TOBEN FOURTH ADDITION

Re: S/D 86-112 - TOBEN FOURTH ADDITION

STAFF REPORT

CASE NUMBER: S/D 86-112 - TOBEN FOURTH ADDITION

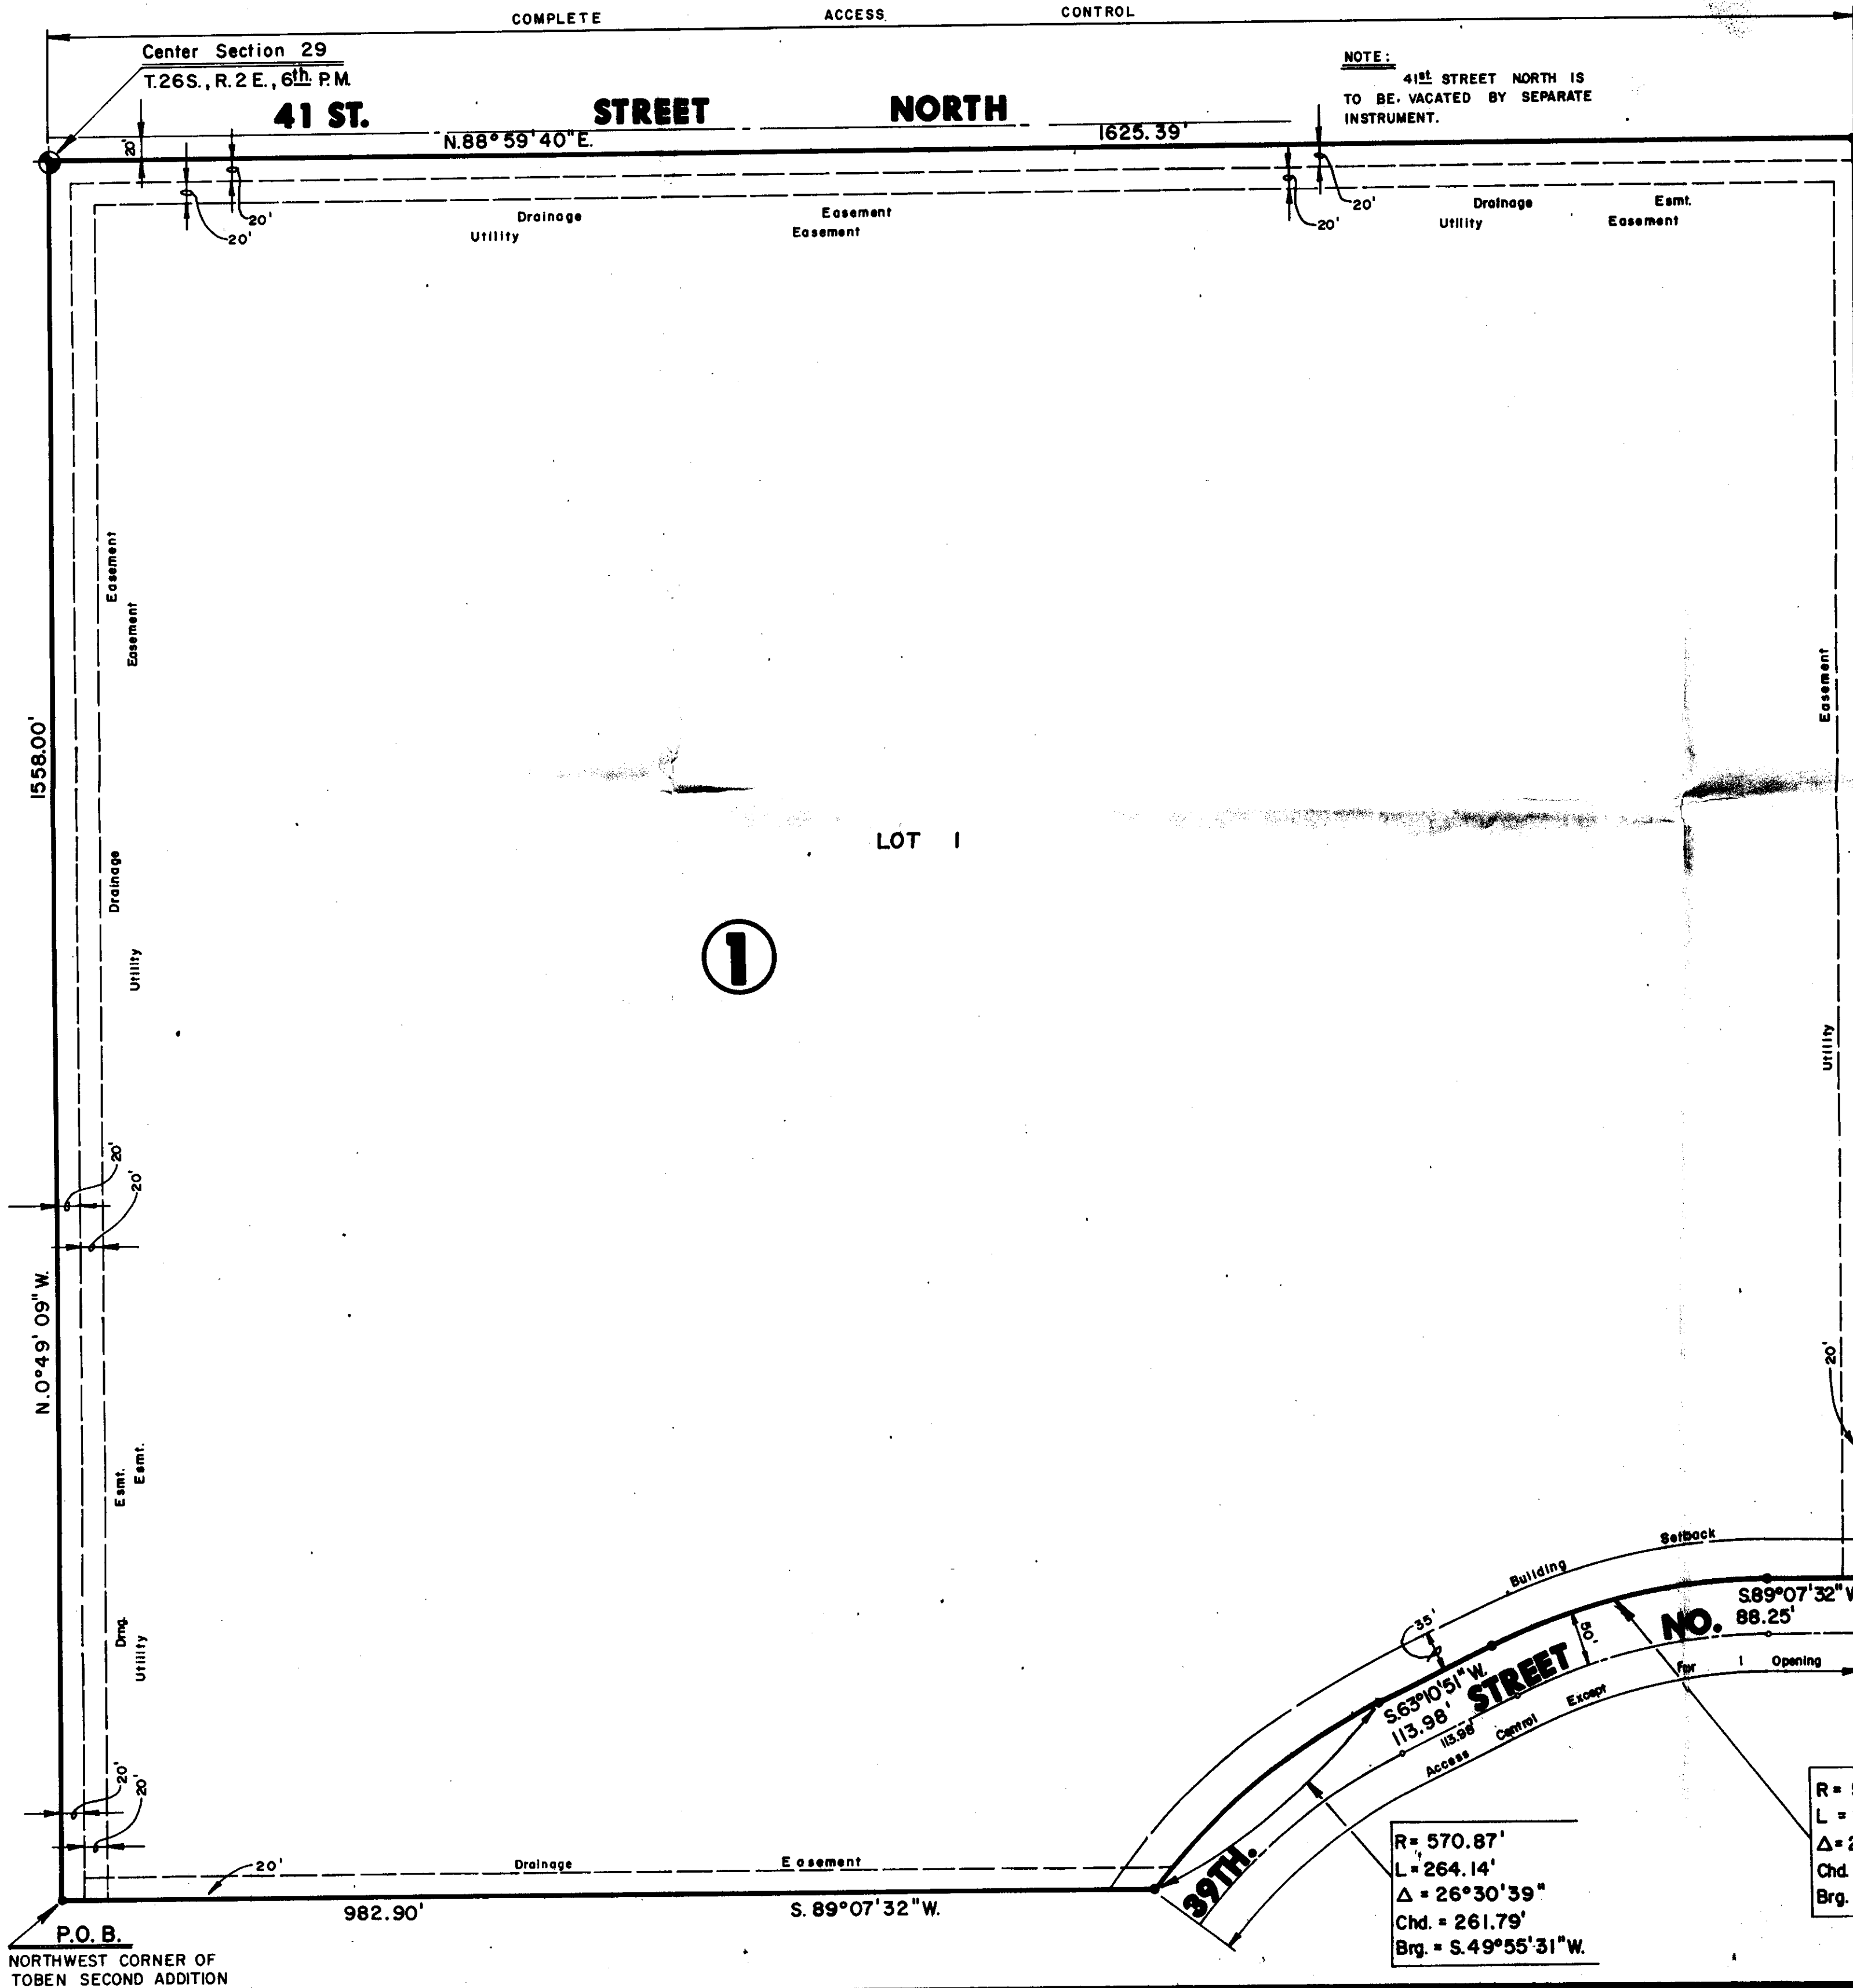
- A. The applicant shall guarantee any drainage improvements required by the platting of this property.
- B. The applicant shall guarantee construction of the storm sewers required by this plat. (A culvert under the railroad is required by the drainage plan).

- D. The final plat tracing shall label the centerline of 39th Street North.
- E. The final plat tracing may, if the applicant so desires, indicate the platting of two (2) access points to 39th Street North.

- F. The north half of 41st Street North, adjacent to the north line of this plat, was dedicated by Sun-Air Estates, but has never been open. This street will not be extended either east or west. Since the south half of 41st Street is not being dedicated by this plat, the north half should be vacated. In this regard, the applicant shall contact the property owners to the north and attempt to get the half-street right-of-way vacated. A portion of this street right-of-way, as depicted on the preliminary plat, will need to be retained as a hammerhead turnaround for Linden.

- I. Prior to this plat being scheduled for the City Council the applicant shall submit to County Engineering a copy of the drainage plan.
- J. Since the drainage plan shows this plat accepting drainage from Lot 1, Block 1, Toben Addition, the applicant shall submit a cross lot drainage agreement to the planning department for review and later recording with this plat.
